**ATLANTIC COAST PIPELINE, LLC  
ATLANTIC COAST PIPELINE**

**DOMINION TRANSMISSION, INC.  
SUPPLY HEADER PROJECT**

**Supplemental Filing  
March 10, 2017**

**Correspondence for the Atlantic Coast Pipeline**

**Figure 1 – Forest Service Landslide Analysis Review Key Plan Map**

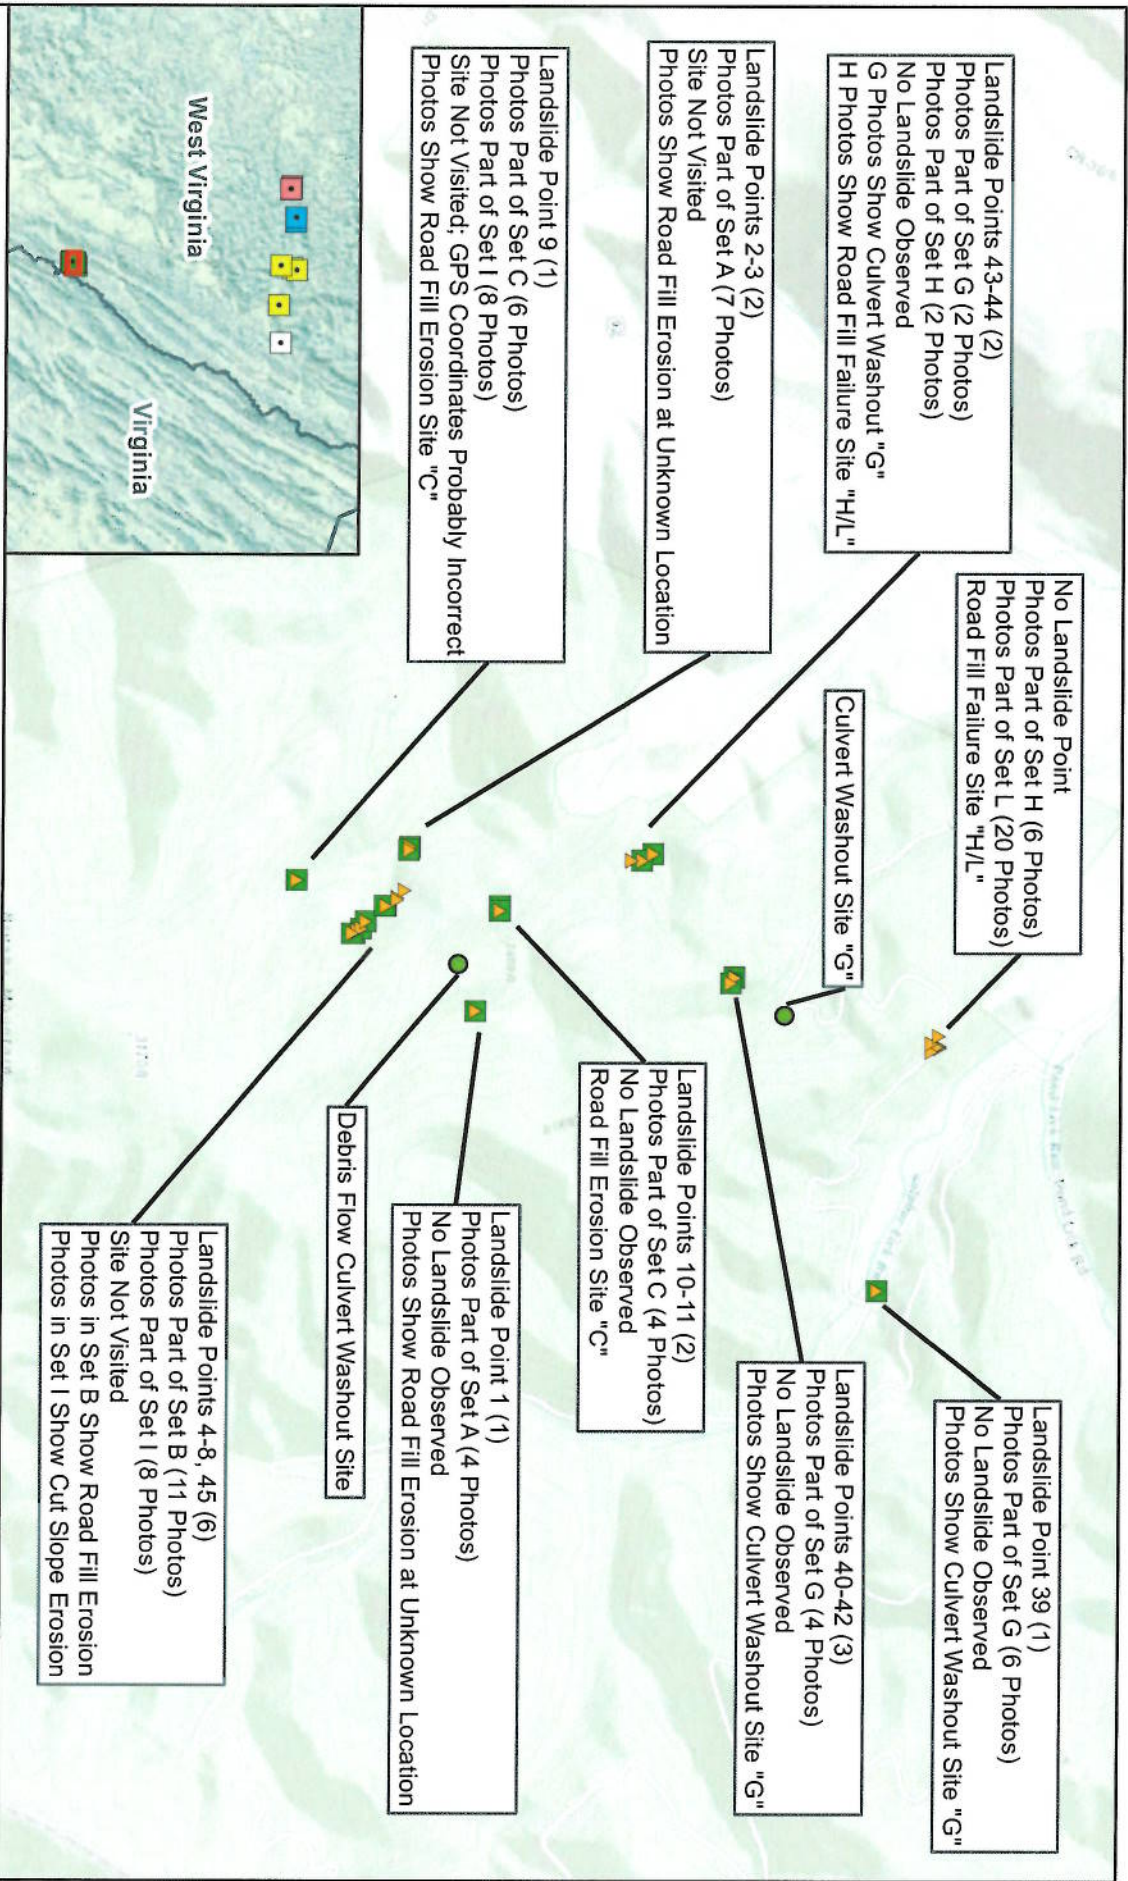
In addition to the 23 December 2016 Forest Service letter to FERC, Geosyntec was also provided with a tabulation of the Latitude/Longitude GPS coordinates of the 48 Landslide Points (see Table 1 in Attachment B) and 164 GPS geotagged photos presented in 14 Sets (A thru N as listed in Table 2). As an initial step in evaluating the relevance of the landslide data the Forest Service analyzed to the ACP Project, Geosyntec plotted the locations of all 48 Landslide Points on four maps (see Figures 2, 3, 4 and 5). One of the Landslide Points (#36 – on Figure 1) fell in a location that was significantly distant from the others and may reflect incorrect GPS coordinates. For this reason, Geosyntec excluded this Point from its analysis. Geosyntec then plotted the locations of all 164 photos (see Figures 2, 3, 4 and 5). The 4 groups are referenced as follows and discussed below:

FS Group 1 (FR 719 on Figure 2- approximately 3 miles NE of White Sulphur Springs, WV);  
FS Group 2 (FR 101 on Figure 3- approximately 10 miles E of Craigsville, WV);  
FS Group 3 (FR 86 on Figure 4 -approximately 15 miles E of Craigsville, WV); and,  
FS Group 4 (FR/SR 150 on Figure 5 -approximately 5 to 10 miles NW of Marlinton, WV).

**Figure 2 – Forest Service Landslide Analysis Review Landslide and Photo Locations FR 719**

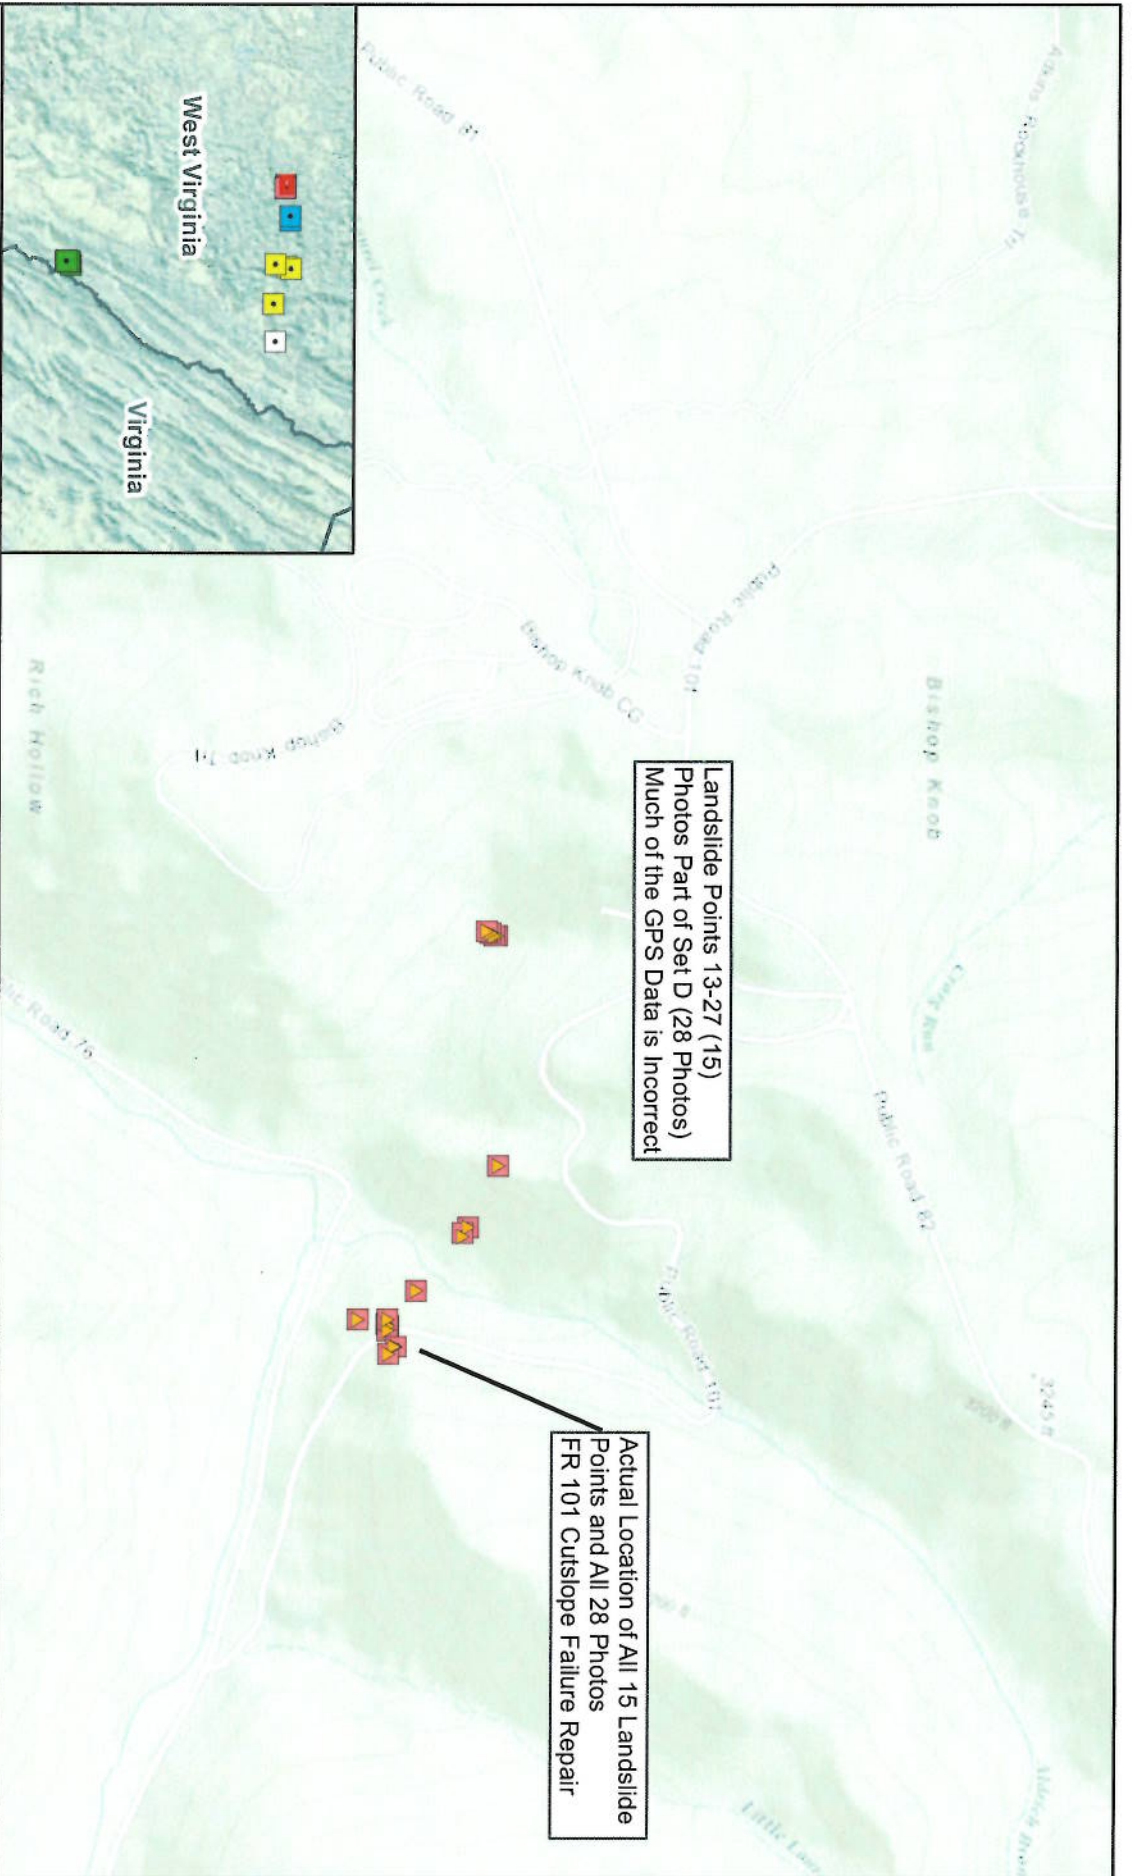
Group 1 is located in proximity to FR 719, approximately 3 miles NE of White Sulphur Springs, WV (refer to Figure 2). We visited this area on Wednesday afternoon 18 January 2017. Locked gates prevented vehicle access, and only 7 of 18 points were visited on foot.

Geosyntec was unable to visit the cluster of 2 Points 2 and 3, as the road was closed to vehicular use by the USFS. However, the 7 photos of Set A attributed to this location appear to clearly show the same site of road fill failure attributed to Point 1 above. The GPS coordinates for the photos are likely inaccurate.

Geosyntec was unable to visit the cluster of 6 Points 4, 5, 6, 7, 8 and 45, due to the road closure and limited time. However, the 11 photos of Set B attributed to this location appear to clearly show a site of road fill erosion (see Photo 06), and the 8 photos of Set I appear to show a site of cut slope erosion (see Photo 07). The GPS coordinates for the photos may be inaccurate.

Similarly, Geosyntec was unable to visit Point 9 due to the road closure. However, the 6 photos of Set C attributed to this location appear to show the site of Road Fill Erosion Site "C" at Landslide Points 10-11, discussed above. The GPS coordinates for the photos are likely inaccurate.

**Figure 4 – Forest Service Landslide Analysis Review Landslide and Photo Locations FR 86**

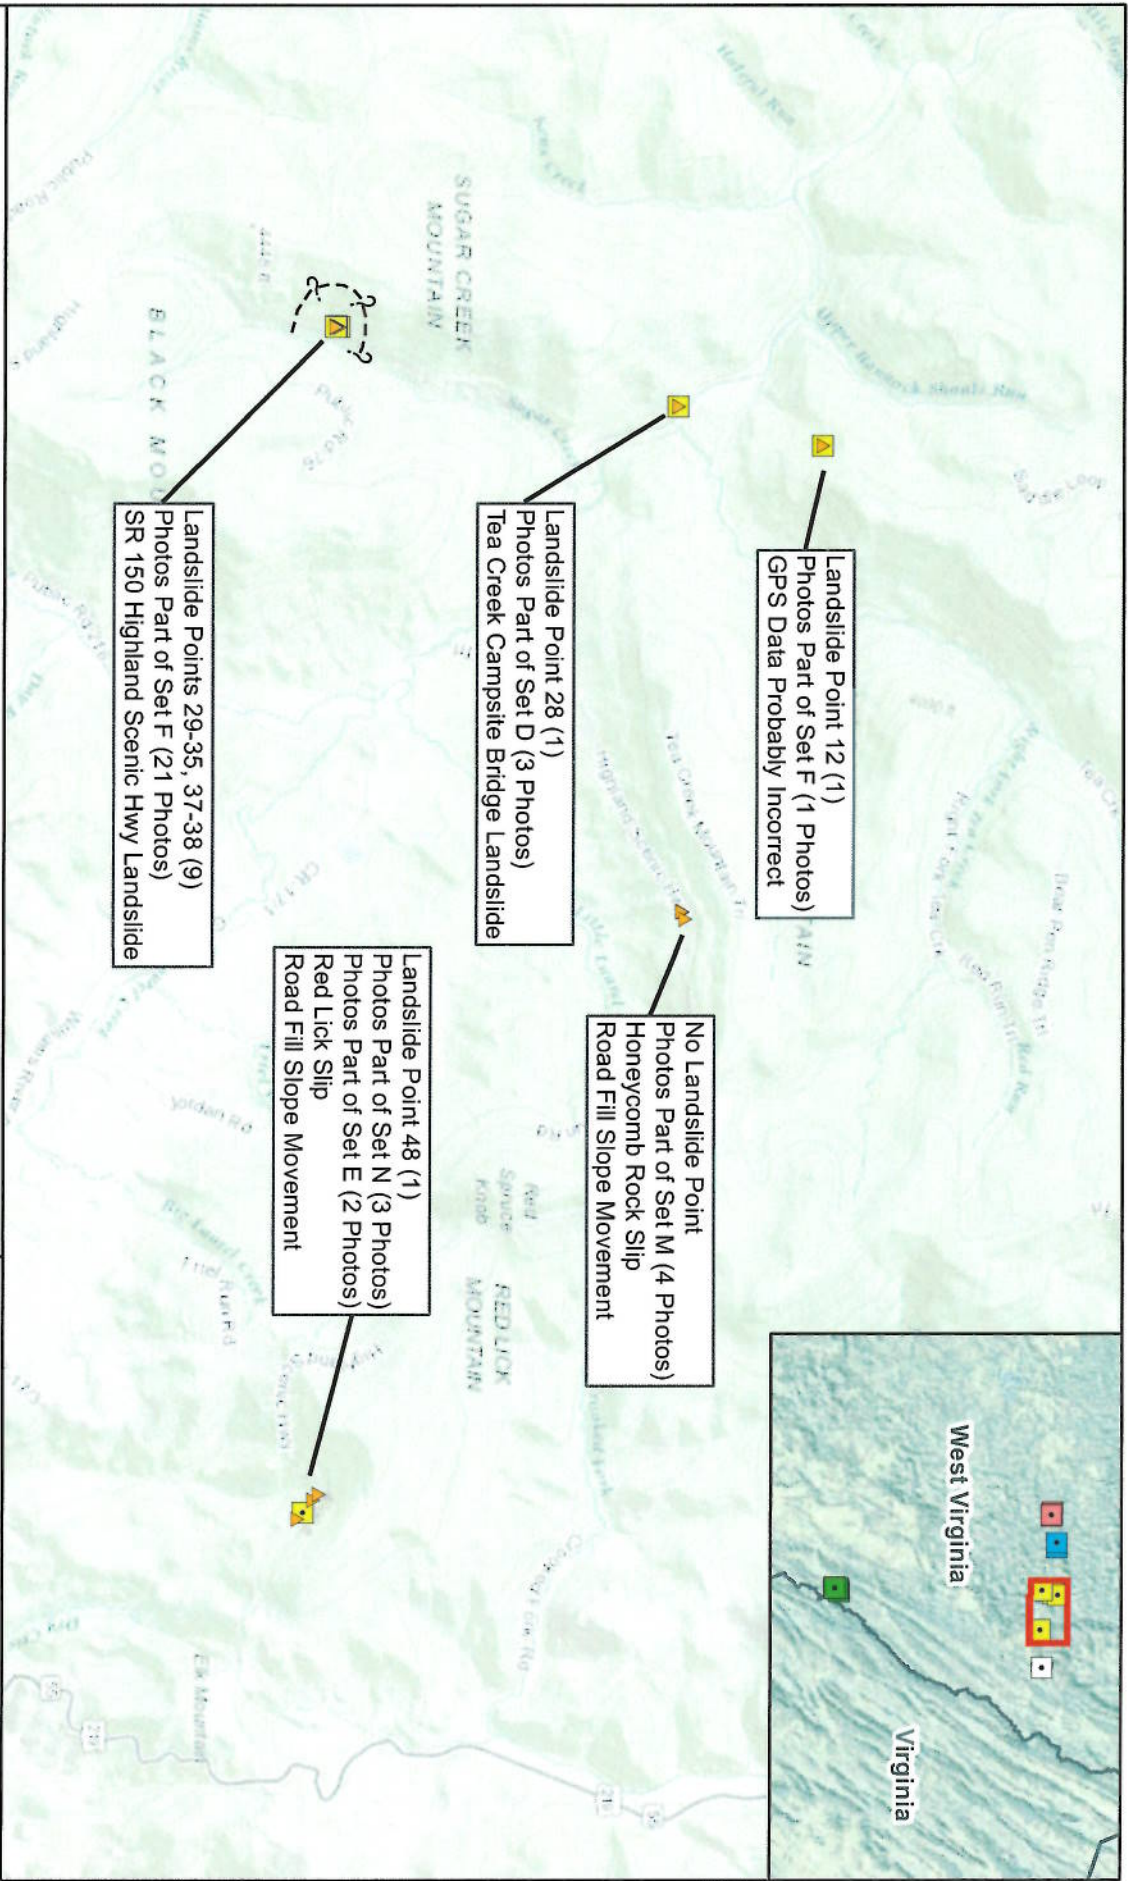
Group 3 is located in proximity to FR 86 (also referred to as Public Road 86), along the Williams River, approximately 15 miles E of Craigsville, WV (refer to Figure 4). Locked gates prevented vehicle access to the sites in this Group and foot access was not possible due to the distances that would have needed to be traversed in the limited time available. However, we suspect that the GPS coordinates for Point 46 are inaccurate, and we suspect that the GPS coordinates for the 11 photographs of Set J attributed to this location are also inaccurate. Further, we believe the GPS coordinates for Point 47 are also inaccurate (there was no photo attributed to this location).
